# HISTORIC AND DESIGN REVIEW COMMISSION

February 15, 2023

**HDRC CASE NO:** 2023-038  
**ADDRESS:** 202 N ST MARYS ST  
130 N ST MARYS ST  
**LEGAL DESCRIPTION:** NCB 405 BLK LOT N 109.8 FT OF 1 & 2  
NCB 405 (SAA- OMI TRACT), LOT 10  
**ZONING:** D, HE, RIO-3  
**CITY COUNCIL DIST.:** 1  
**LANDMARK:** Individual Landmark  
**APPLICANT:** Anthony Byron  
**OWNER:** St Mary's Catholic Church  
**TYPE OF WORK:** Construction of a 17-story hotel tower  
**APPLICATION RECEIVED:** January 31, 2023  
**60-DAY REVIEW:** Not applicable due to City Council Emergency Orders  
**CASE MANAGER:** Edward Hall  
**REQUEST:**

The applicant is requesting a Certificate of Appropriateness for approval to construct a hotel tower to feature seventeen stories, not including the river level, to feature an overall height of approximately 203 feet. The proposed hotel received final approval in May 2019 but has since been amended regarding height.

17-STORY SHADOW PROFILE  
14-STORY SHADOW PROFILE

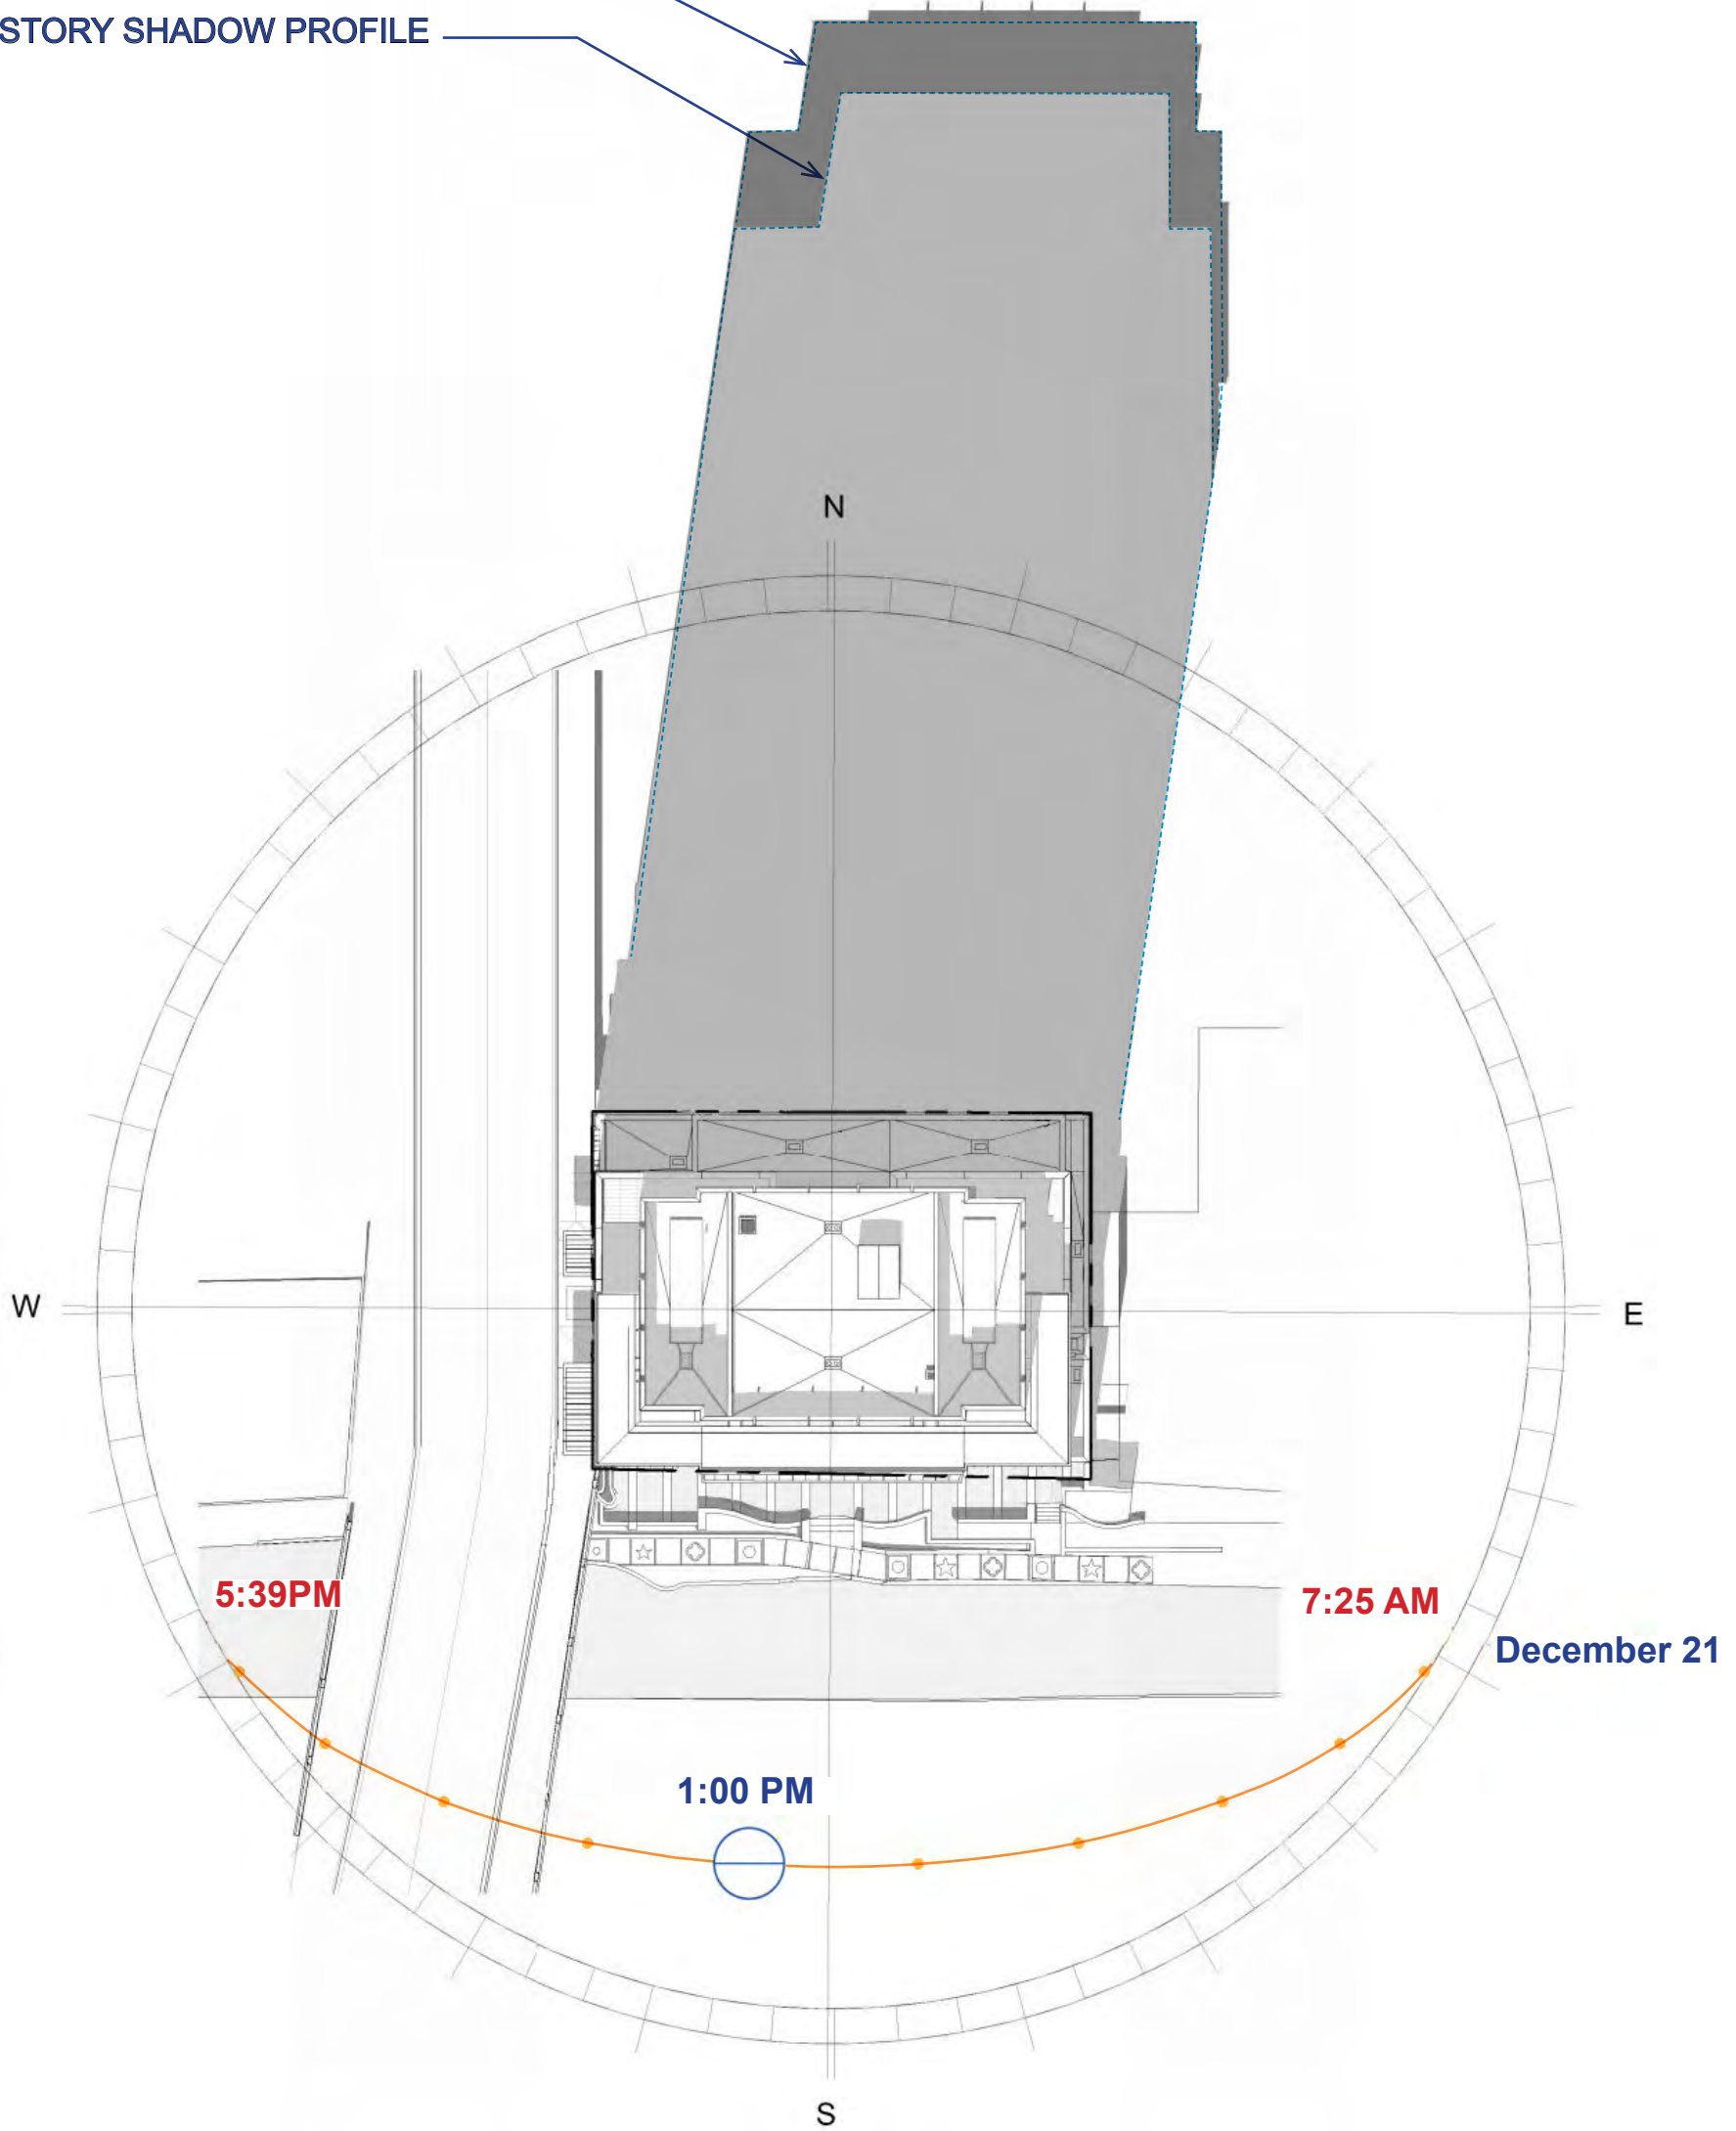
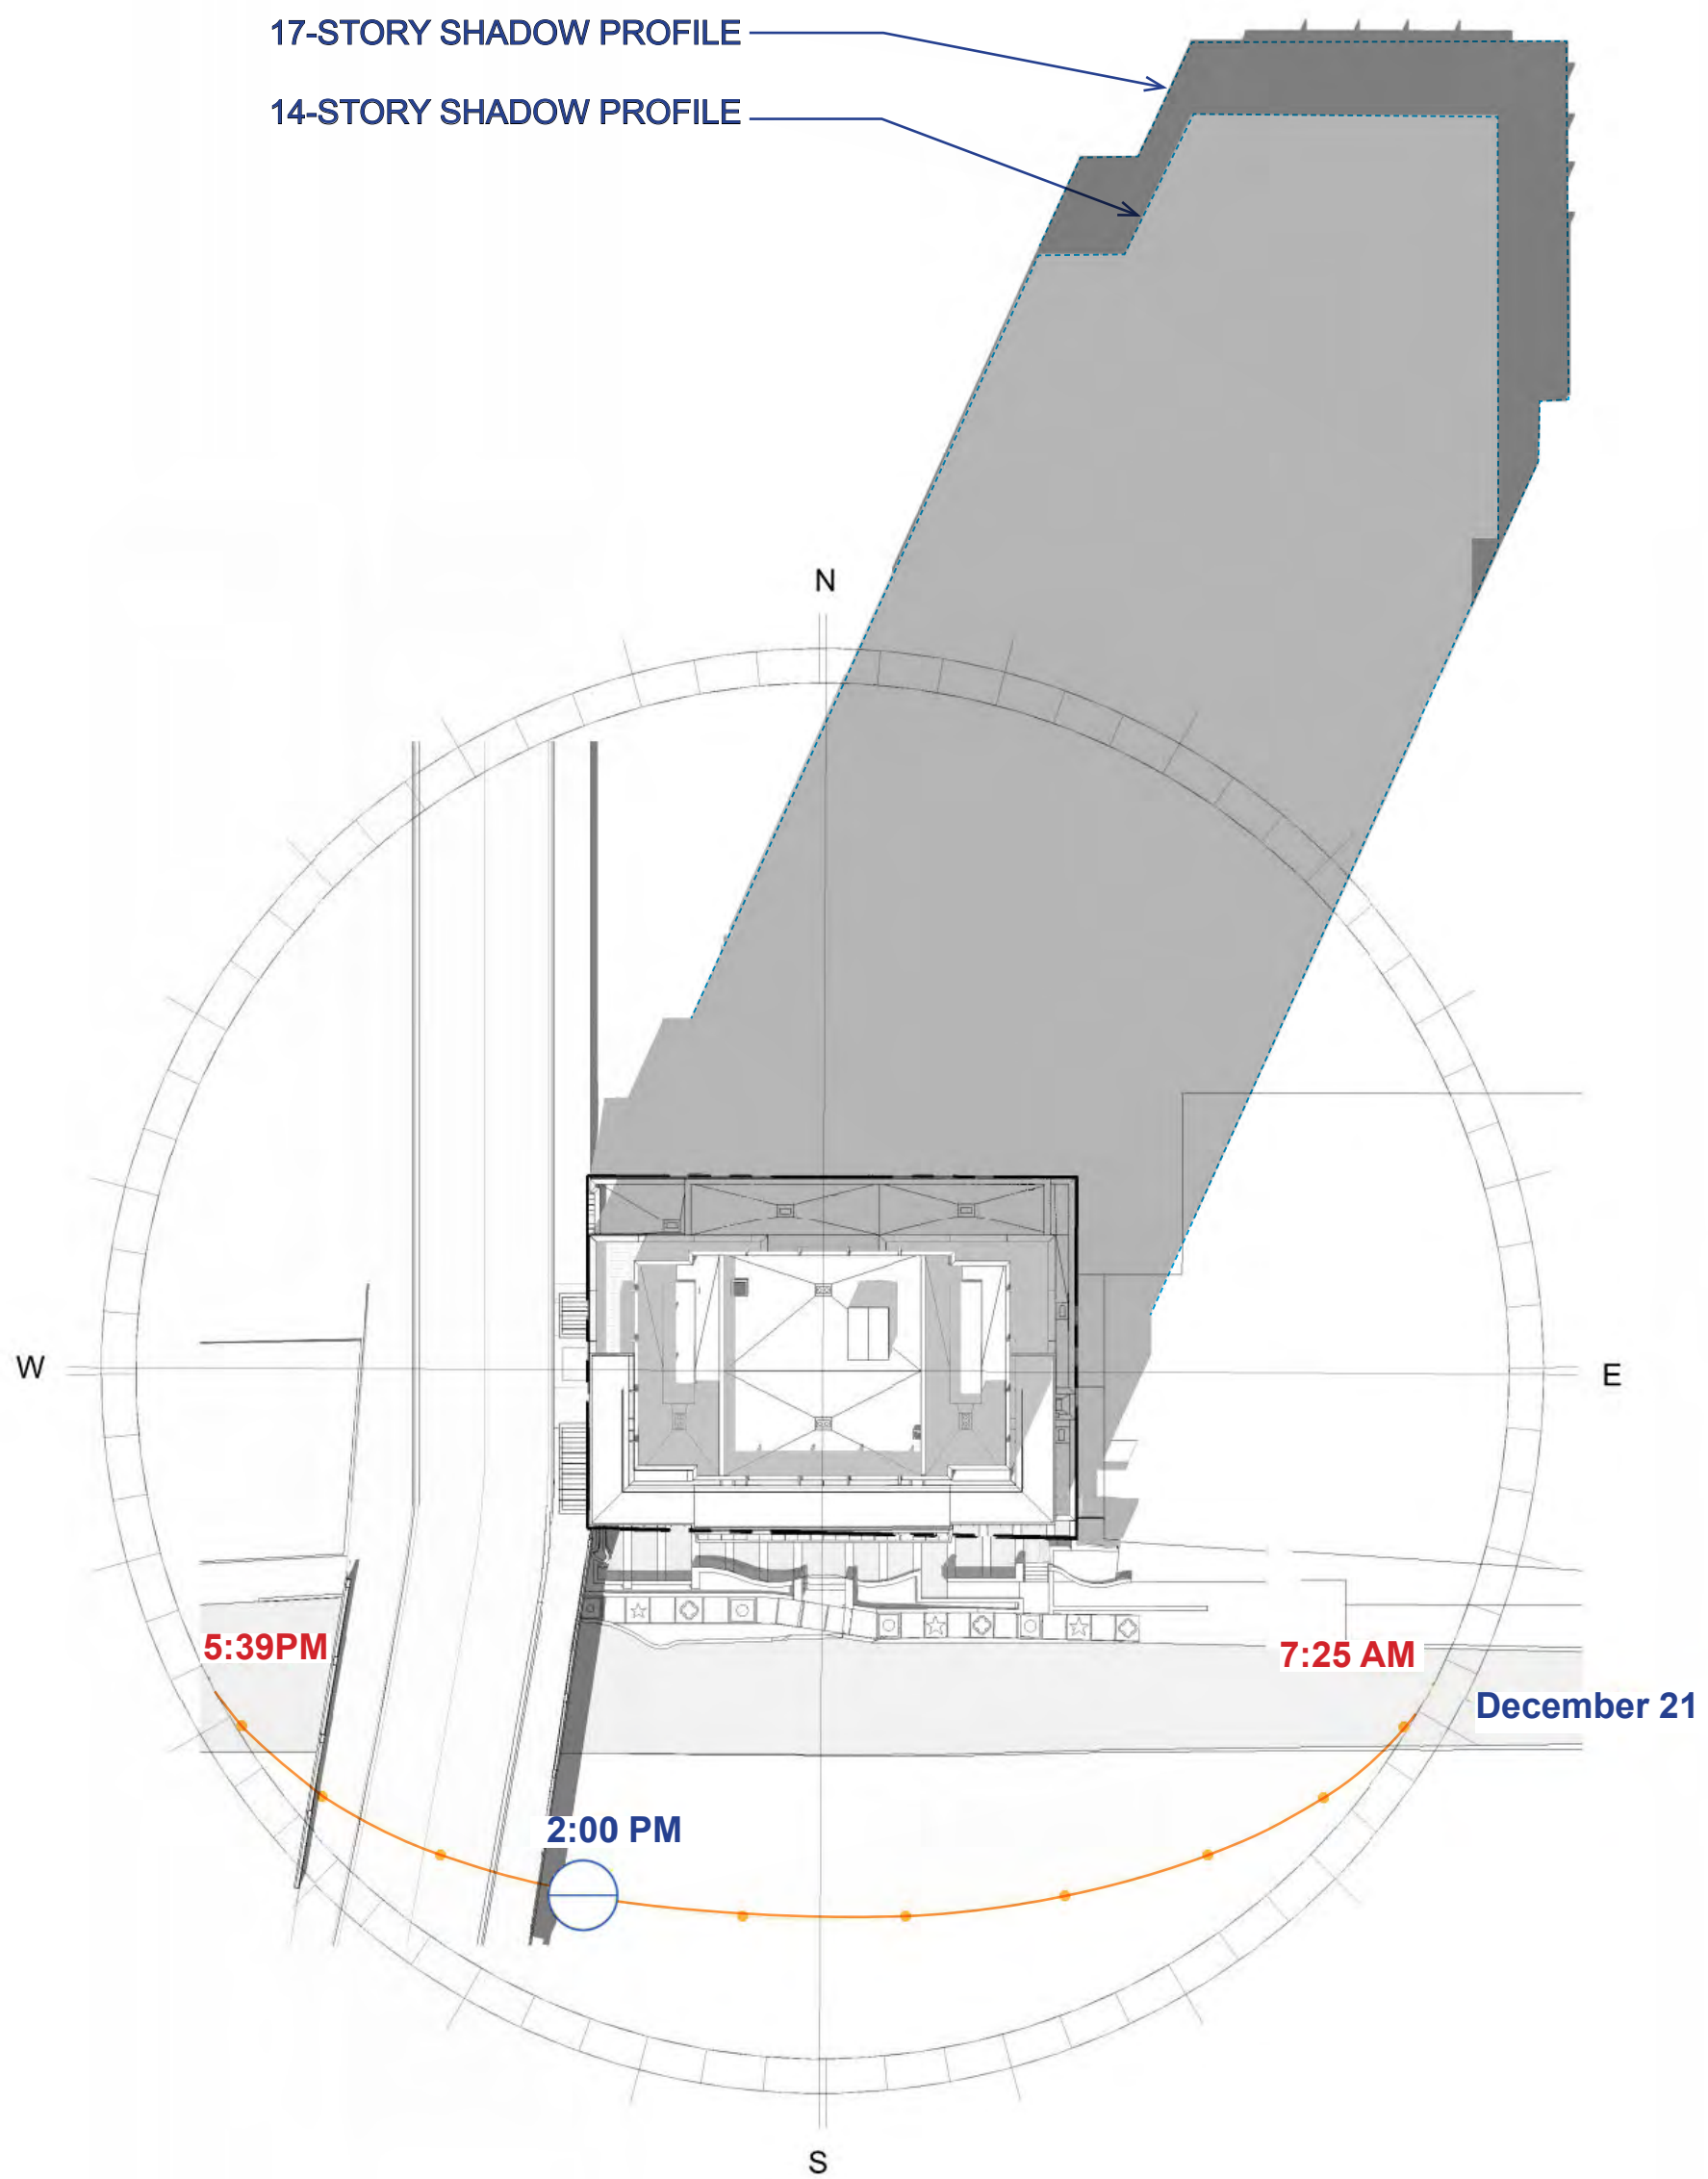
- ix. Ensure adequate solar access on the River Walk.
